Access Compliance Report Public Rights-of-Way (Curb Ramps)

Main Street: FOSTER_RD Cross Street: KERTH_DR Location: SE

ADA ID: RPRK211217111733 Ramp Type: Type 1 - Perpendicular Diagonal Initial Pass/Fail: Pass Overall Compliance: No Severity Score: 10

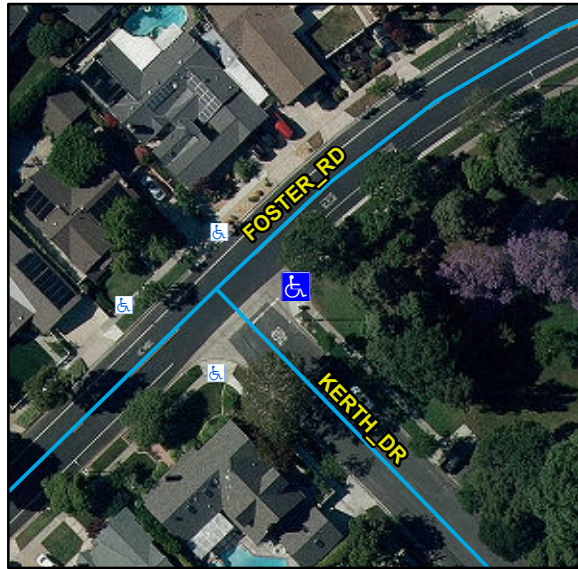
R204.3, R304.2.2-Perp, R304.3.2-Para, R305, STD 1115

Remove & Replace Curb Ramp With Two New Directional Ramps or Equivalent.
